# MEMORANDUM

| **Our Ref:** | ET/DC/DB/P/2024/1157 | **Your Ref:** | P/2024/1157 |

**PROPOSAL: RHYDDHAU AMOD 7 (DEUNYDDIAU), 22 (TIRLUNIO), 26 (FFYRDD MEWNOL), 28 (CYFLEUSTERAU PARCIO A THROI) A 31 (HALOGIAD) CANIATÂD CYNLLUNIO P/2018/0053 / VARIATION OF CONDITIONS 7 (MATERIALS), 22 (LANDSCAPING), 26 (INTERNAL ROADS), 28 (PARKING AND TURNING FACILITIES) AND 31 (CONTAMINATION) OF PLANNING PERMISSION P/2018/0053**
**LOCATION: RUABON BUSINESS PARK SITE, WREXHAM, LL14 6TE**

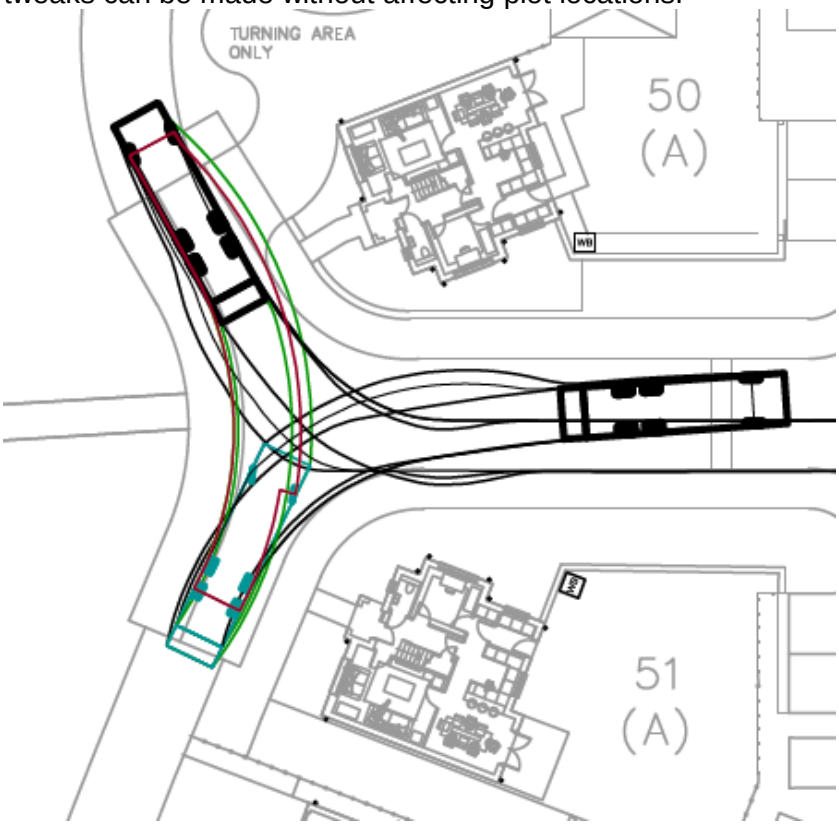
1. Swept path proposals have been provided in the plan titled Condition 26 and 28 – Refuse Vehicle Swept Path P1. Some of those provided on the plan appear to overrun kerblines, however we suspect this can be adjusted. For example, the screenshot below shows the southern kerbline with tracking overhanging the kerbline on the southern footpath. There is space for adjustment to the north footpath, and the west end of the turning head. For the Section 38 further consideration and adjustments will be required, but we do not believe this is a matter that will affect the layout significantly for variation of the condition, provided minor tweaks can be made without affecting plot locations.
